PROPOSED CHANGE NO. 6
FOR THE
SOUTHWEST EXPERIMENTAL FAST OXIDE REACTOR

Re: LICENSE DR-15

DOCKET 50-231

GENERAL ELECTRIC COMPANY

FIGURE 1 CALIBRATION OF SUB-PROMPT SLUG

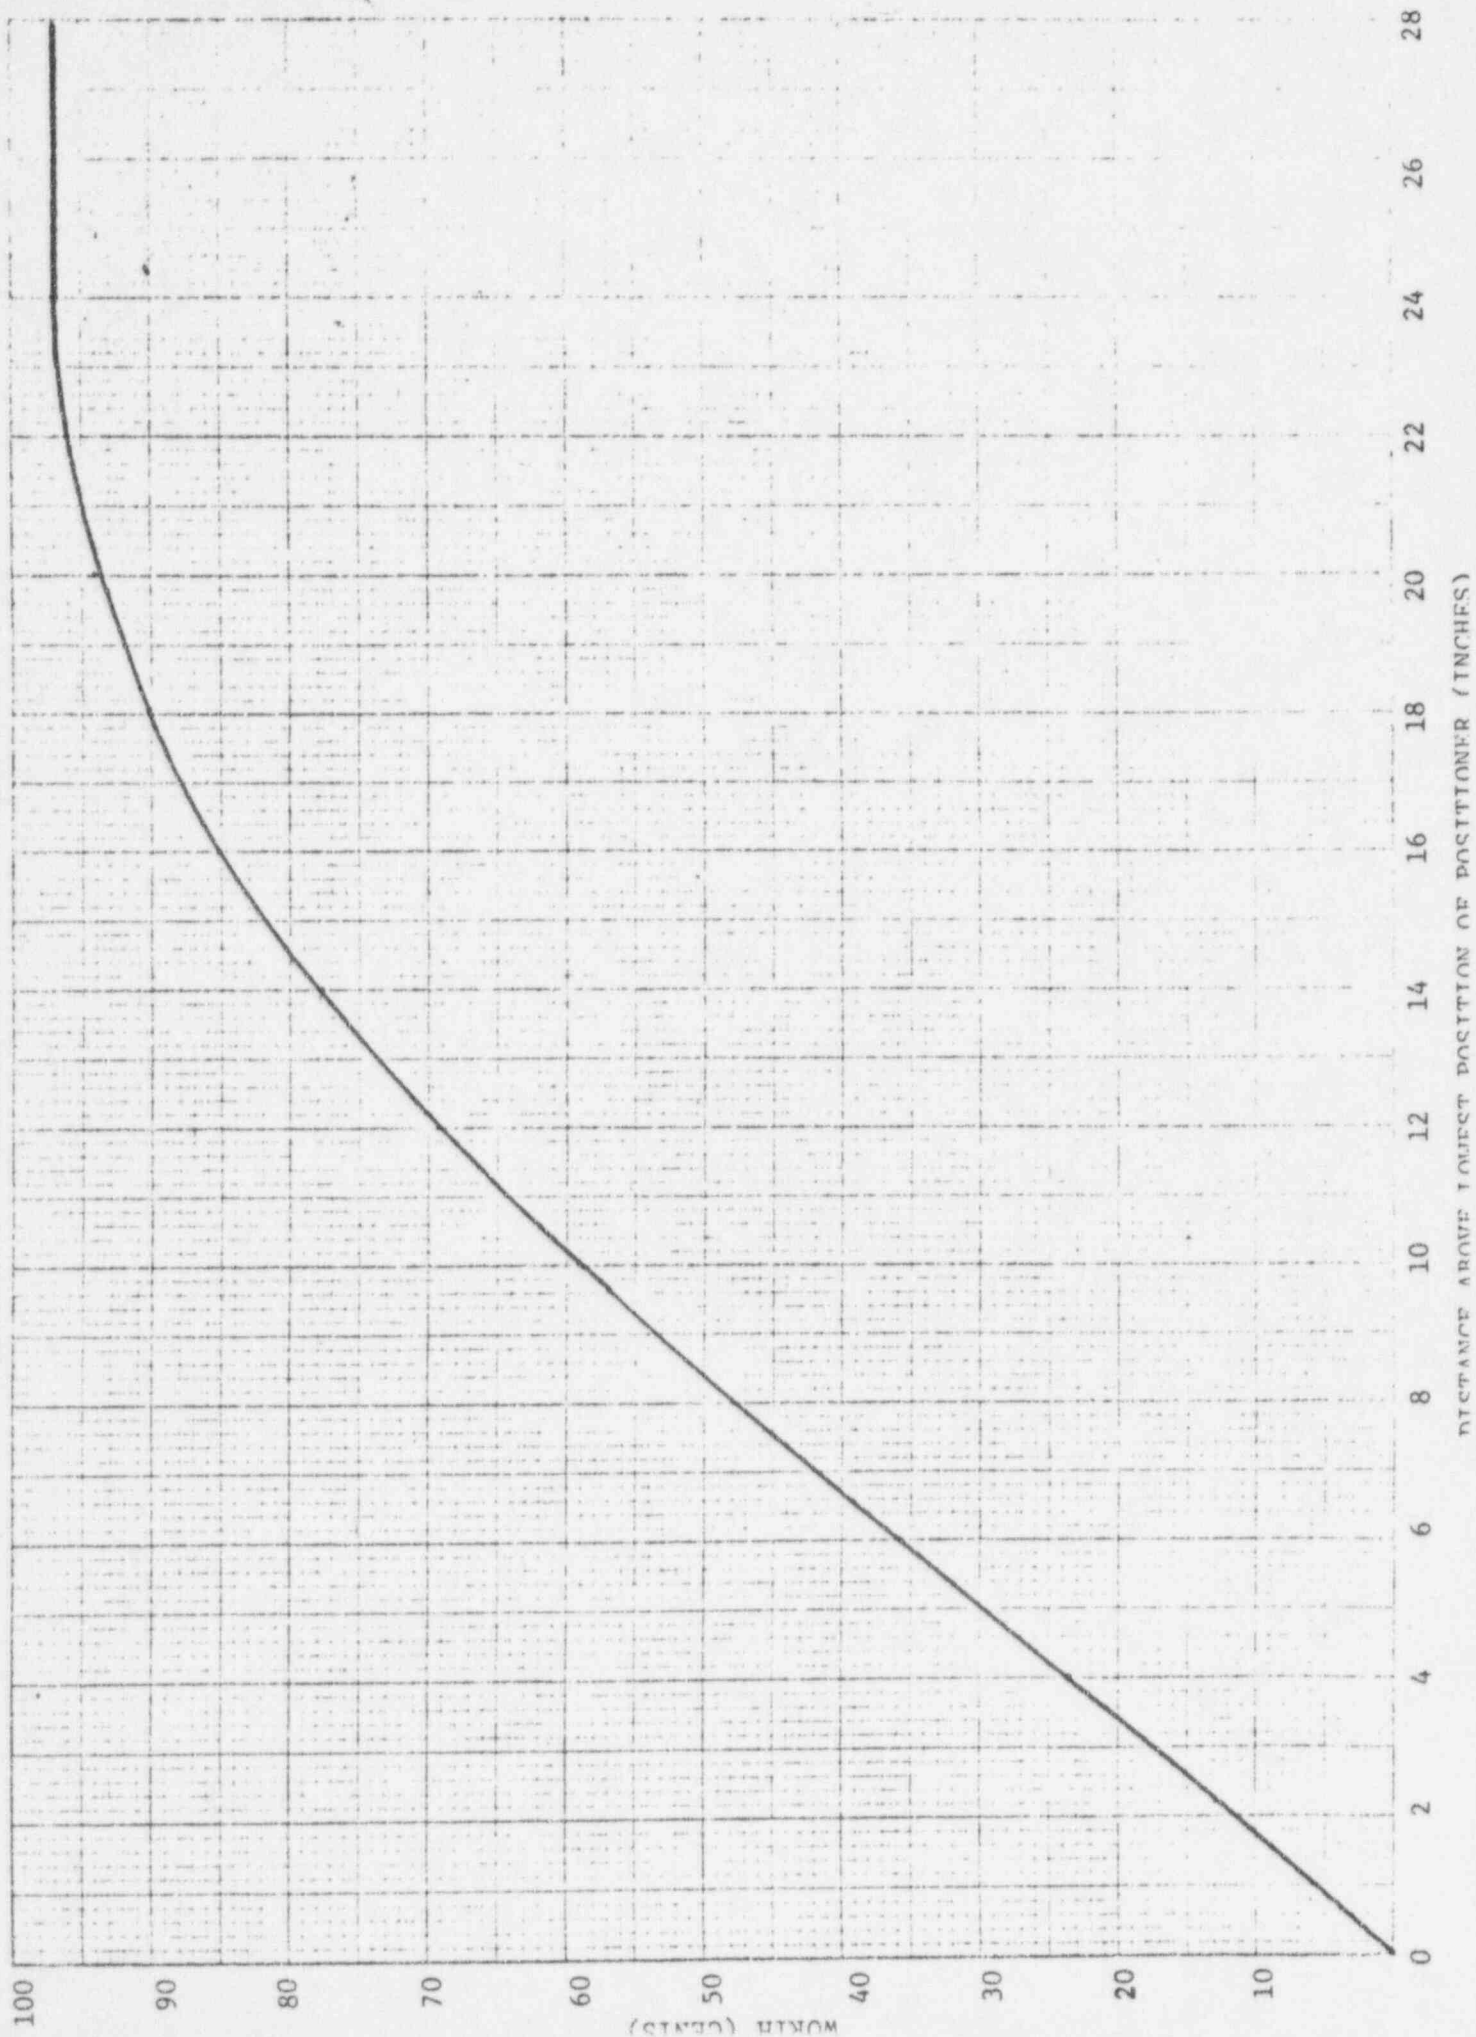
$\frac{dk}{dx} \equiv$ reactivity change per inch movement of poison slug as determined from slug worth versus position measurements,

FIGURE 2 CHARACTERISTICS OF SUB-PROMPT SLUG

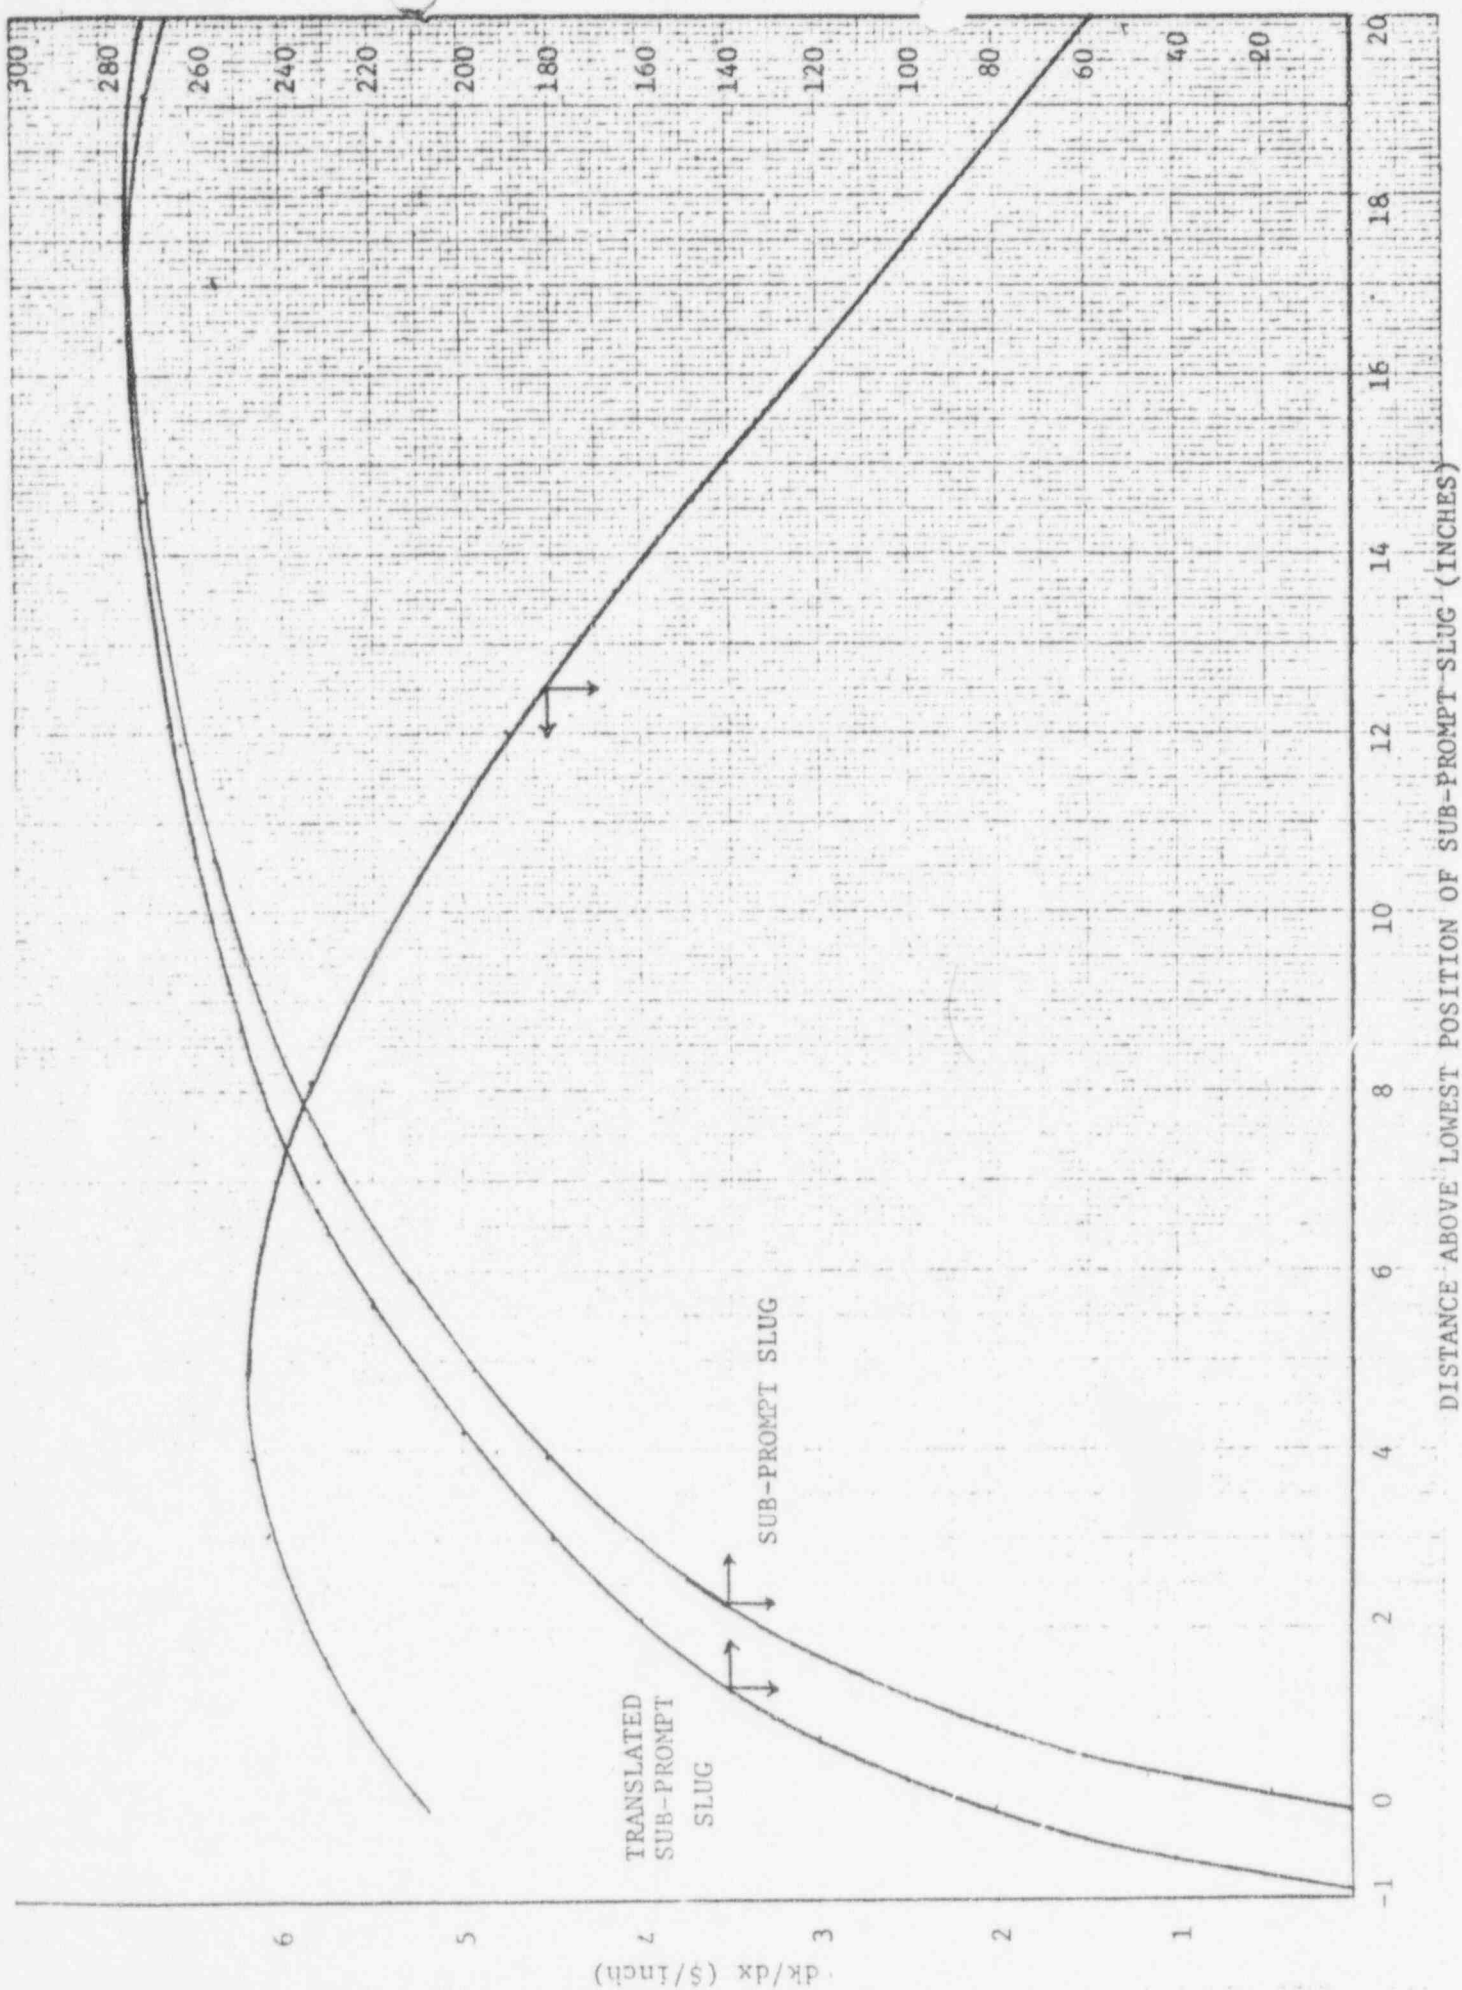
The minimum 20-inch travel time of 0.097 sec, necessary to give an insertion rate of 20\$/sec for a slug worth 1.30 dollars, has been determined by ratioing the rate which would have been obtained from the sub-prompt slug, if the poison section had been positioned 0.9 in. lower in the rod, a position that corresponds to the location of the poison section for the super-prompt slug. The sub-prompt slug worth with the poison section at this lower position would have been 101.1¢. Figure 1 gives the measured worth versus position characteristics of the sub-prompt slug. Figure 2 shows the slope, $\frac{dk}{dx}$, of Figure 1 and also the FRED velocity characteristics as reported in Reference 2. The insertion rate that would be obtained by firing the sub-prompt slug so that the initial position of the poison section corresponds to the position of the poison section of the super-prompt slug can be determined by shifting the velocity versus position curve for the sub-prompt slug by 0.9 in., as shown on Figure 2. The reactivity

change per inch ($\frac{dk}{dx}$) of the poison section as a function of position would not be shifted.
